Clause 23 Further Information Request Response Table – WBP PPC

Private Plan Change Application – Whenuapai Business Park – Additional Information Request

**Neil Construction Limited - Brigham Creek Road
Brigham Creek Road, Whenuapai, Auckland
Request for Further Information**

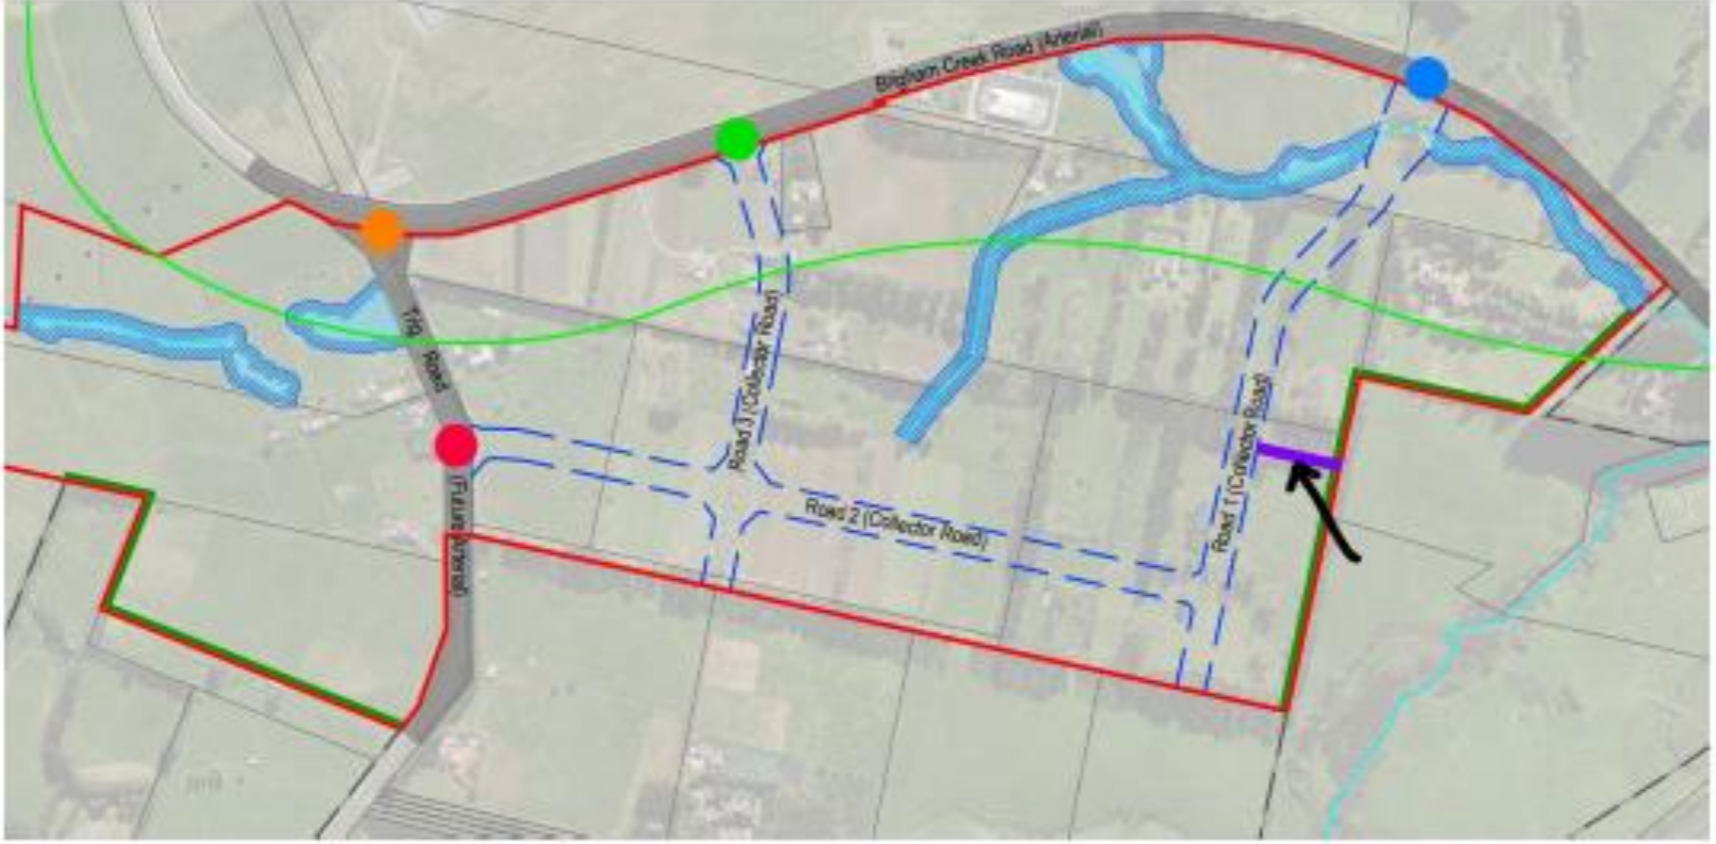
11.	Trig Road access	Please assess if direct access onto Trig Road can be safely provided if a fourth leg is not provided at the proposed Trig Road / WPRPC roundabout.	<p>Section 4.5.2 of the ITA assesses the Trig Road / WBRPC internal road roundabout. The roundabout is designed to have three legs, consisting of two legs on Trigg Road and one leg on the WBRPC internal road network.</p> <p>No fourth leg to the west is shown in the plans, which would provide access to the orange stage in Appendix I Staging Plan.</p>	<p>This matter is addressed in Section 4.5.2 of the ITA.</p> <p>A fourth leg would provide access to 96 and 96a Trig Road, but would not provide access to 94 Trig Road. Existing and separate vehicle access is provided to 94, 96 and 96A Trig Road and these sites are held in different ownership. The existing access is safe and efficient. Future access will be subject to the provisions of E27 Transport. Site access can be designed to accommodate the relevant speed limit of Trig Road and the likely users.</p>

<p>We note that Section 4.5.2 of the ITA states: “There is potential for the proposed Trig Road roundabout to also provide access to the WBPPC land on the western side of Trig Road, alternatively this land can be accessed directly by utilising the median that is to be provided as part of the trig Road upgrade.”</p> <p>If no fourth leg at the roundabout is currently proposed, then the assessment should consider direct vehicle access being provided from Trig Road, and ensure sufficient visibility and separation from adjacent intersections can be provided.</p> <p>While Trig Road is currently classified as a local road in the Unitary Plan, the Notice of Requirement for Trig Road anticipates this being an arterial road, which means vehicle access restrictions in the Unitary Plan could apply in the future.</p>	
	Changes to precinct provisions			<p>In addition to the amendments above, the following precinct provisions have been amended:</p> <p>(4) Wastewater and Water Supply Infrastructure</p>

Figure 3: Cross Section at 162 Brigham Creek Road - 1% AEP Post with 100% Box culvert capacity

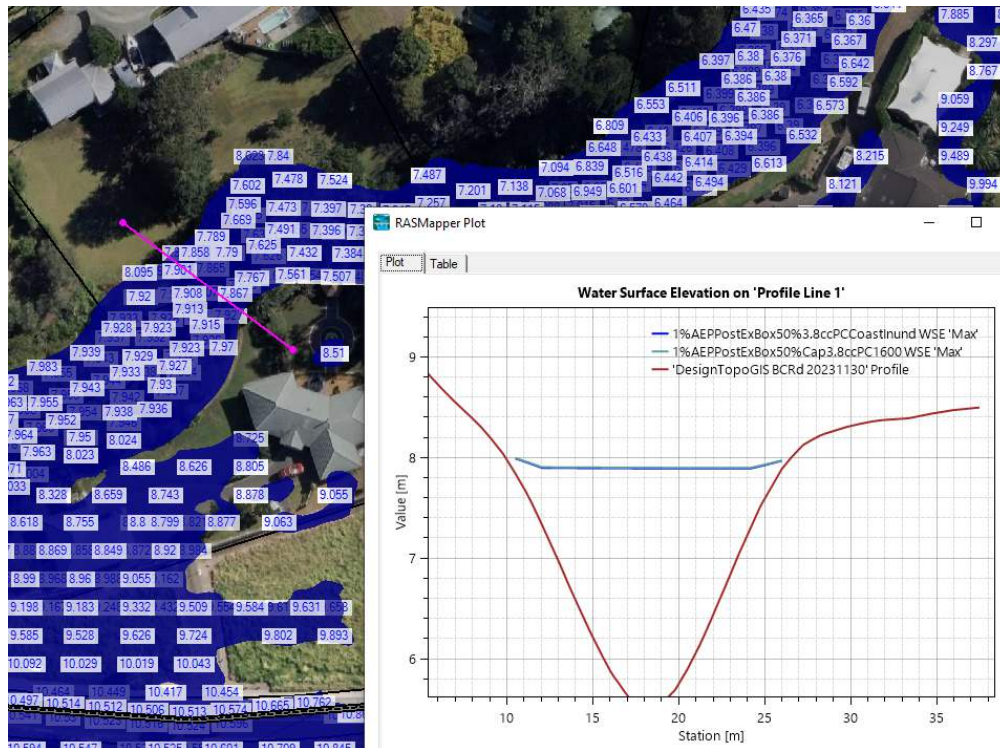
The cross sections below show the flood depths of the normal flood depth (without coastal inundation) shown in light blue, and with coastal inundation allowed for in dark blue). The cross sections were taken at 162 Brigham Creek, and further downstream along the boundary of 59 and 65 Kauri Road. The sections show no difference in the flood level at 162 Brigham Creek Road between the two scenarios but does show a difference further downstream at 59 and 65 Kauri Road. This indicates that the downstream boundary condition does affect the downstream flood level but does not affect the flood level at the properties assessed in the flood assessments.

The results show that the limits of the tail water's effect were downstream of 162 Brigham Creek Road. That is to say that the modelled tailwater had no effect on 162 Brigham Creek Road, or upstream of this property, and therefore had no effect on the properties assessed.
